Comments on Pending Administrative Land Use Decision

05SPR-23

Comments in reference to File: 2023.08.17-ApplicationMaterials-05SPR-23
Deadline for comments: 19 Oct 2023
Subject Property Location: 16545 William Foss Road
Comments submitted by: Chris & Jody Evans, 51467 Evans Way

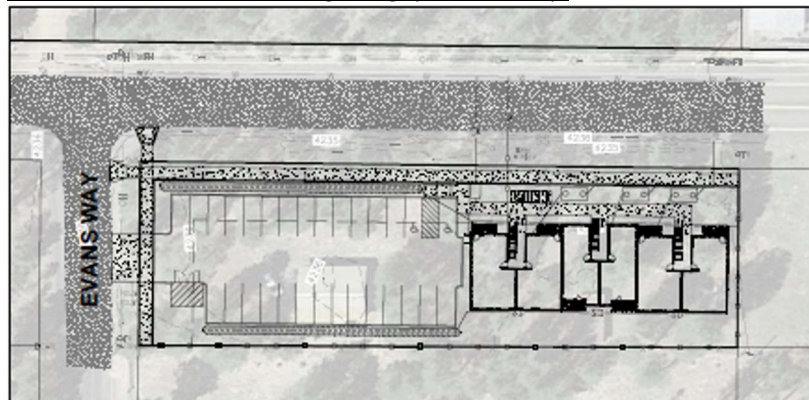
- F. Minimum number of parking spaces
 - The plan calls for 29 parking spaces on the lot. There are 34 bedrooms in the proposed multi-family structure.
 - Where does overflow parking go? The residential street does not have approved burms for parking and it is a residential street with no parking in the right-of-way.

- I've noticed on other recent multi-family housing that has been placed in La Pine, that the streets abutting the property are littered with cars. This is not workable on Evans Way.

- There are no sidewalks on Evans Way.
 - The pedestrian traffic of residents and neighbors (and dogs) walk in the street down the residential street.
 - Putting cars along the street (not in front of the subject property) will cause problems with the neighbors – don't park on my property, and the pedestrian traffic will be forced to walk farther out into the street.

- Comment: There should be Off-Street parking to the maximum of this requirement since the MFU abuts a main road (William Foss Rd) and a residential street with no on-street parking (Evans Way). Overflow parking is a major concern as there is no ability for street parking on either William Foss Rd or Evans Way.

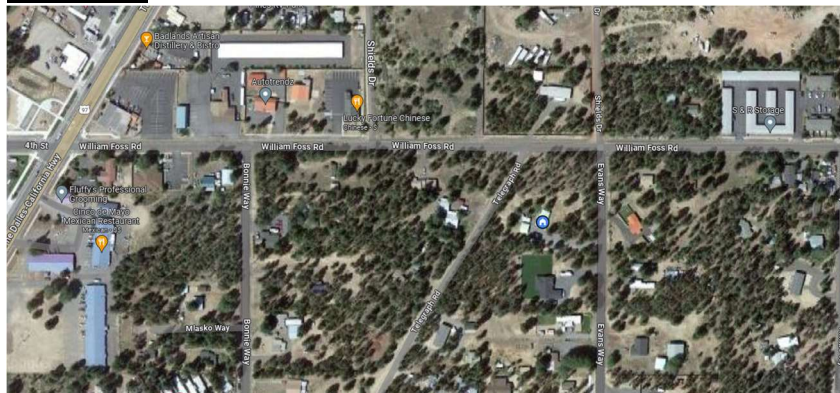
- C. Inadequate existing streets
 - Comment: Pushing the flow of traffic onto the residential street with no improved curbs, no continuous sidewalks and inadequate width to support the increased

vehicular and pedestrian traffic should require the developer to improve the existing street (Evans Way). Using William Foss Rd for the property access (since this is the address of the property) will remove this burden.

- Adding the 18 unit traffic flow to William Foss Rd off HWY 97 is a concern.
 - The turn lane does not exist off HWY 97 which causes traffic turning East off HWY 97 onto William Foss Rd to stay in the travel lane. This can be surprising to HWY 97 motorists since there is a turn lane in the middle of HWY 97, it just cannot be used due to the pedestrian crossing structure just before William Foss Rd traveling South.
- Comment: The intersection of HWY 97 and William Foss Rd should be assessed in view of the increased traffic on William Foss Rd due to the 18 unit MFU.
